REPORT TO THE CALGARY PLANNING COMMISSION

DEVELOPMENT PERMIT	ITEM NO: 06	
	FILE NO:	DP2012-0285
	CPC DATE:	October 11 2012

PROPOSAL: 229 Unit Multi-Residential Development; Restaurant: Licensed - Medium

PROJECT: A410

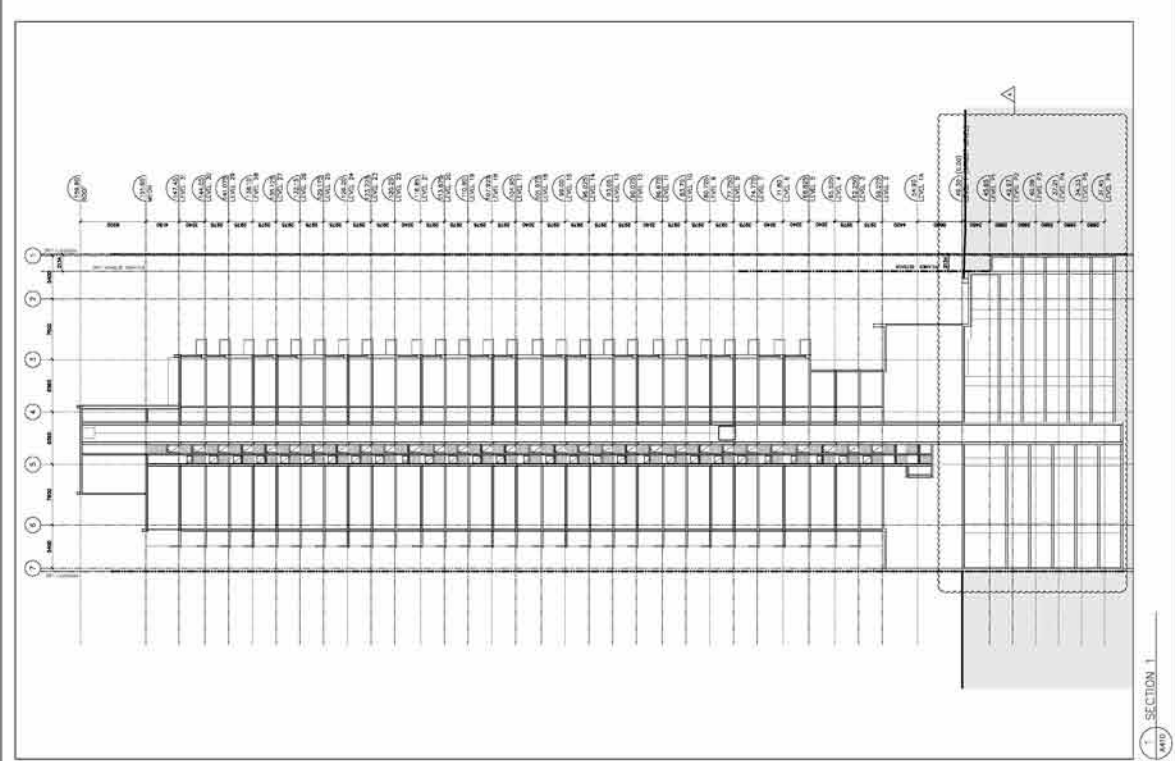
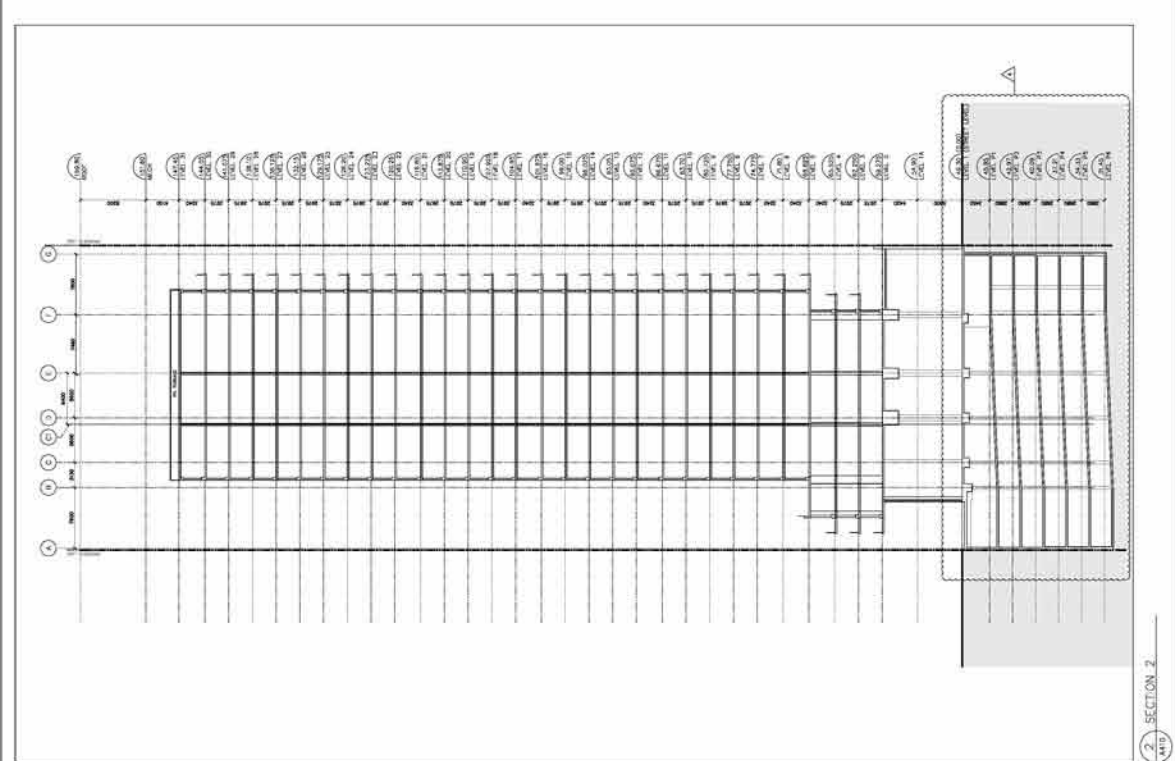
- b. Indicate (on all relevant plans) a minimum vertical clearance of 3.5m from top of grade to top of parkade level 2 roof for the proposed parkade encroachment within the bylawed setback lands. Currently only 3.45m has been provided. Show this change on all relevant plans (A411, A412, etc.)

1 WATER FEATURE SCHEMATIC PLAN (L1.21) SCALE 1/16

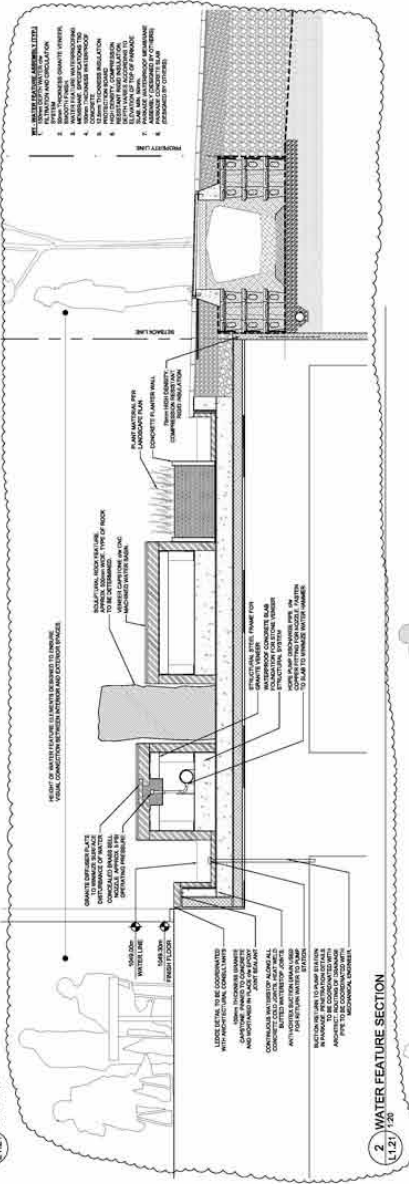
Comment	Applicant's Response
<p>1. The Panel feels that seasonal use of the fountain needs to ensure that it functions well as a sculpture during the winter months and shoulder seasons.</p>	<p>Water features in general face challenges in Calgary's climate due to the long winter season. This feature has been designed to act as a sculptural element throughout the year, with or without water. In winter, while the water will be drained, the large slabs of granite will catch falling snow, creating a distinctive contrast between the fresh white snow and the dark black of the granite. The slabs will vary in height, adding texture and patterning to the effect. Lighting will continue to function, enhancing and highlighting the beauty of winter. In this way, the climatic changes of the seasons are embraced and celebrated, ensuring this feature remains a feature throughout the year.</p>
<p>2. The Panel questions whether the currently proposed location of the sculpture is appropriate and encourages the Applicant to consider locations nearer the corner of 10 Avenue & 6 Street SW.</p>	<p>Unfortunately there is insufficient room to place the sculpture closer to the intersection of 10 Avenue and 6 Street SW. Once the corner sight triangle and by-law mandated ROW setbacks are taken into consideration, there is very little room left to prominently site the sculpture at the intersection. As such we have created a secondary publicly accessible parkette space along 6 Street SW designed around the sculpture.</p>

<p>3. The Panel feels that additional birch trees as part of the overall integrated landscape design would soften the scale of the fountain.</p>	<p>While additional Birch has not been added, we have increased the size of the planting bed and expanded the plant list. The end result will be to soften the scale of the fountain as suggested.</p>
<p>4. The Panel questions whether some of the bicycle parking is appropriately located and encourages the Applicant to consider placing some of the bicycle parking on the 10 Avenue side of the building.</p>	<p>Noted, and additional bike racks have been added along 10 Avenue SW and within 15 metres of the restaurant entrance.</p>
<p>5. The Panel encourages the Applicant to ensure that the height and scale of the landscape components on 10 Avenue and patio on 6 Street do not form a visual obstruction from exterior to interior and vice versa.</p>	<p>The drawings have been clarified. The height and scale of the landscape components along 10 Avenue SW are of a height that seated restaurant patrons will have an unobstructed view across the water feature to the plaza. Eyes on the street and visual permeability were key considerations in the design.</p>
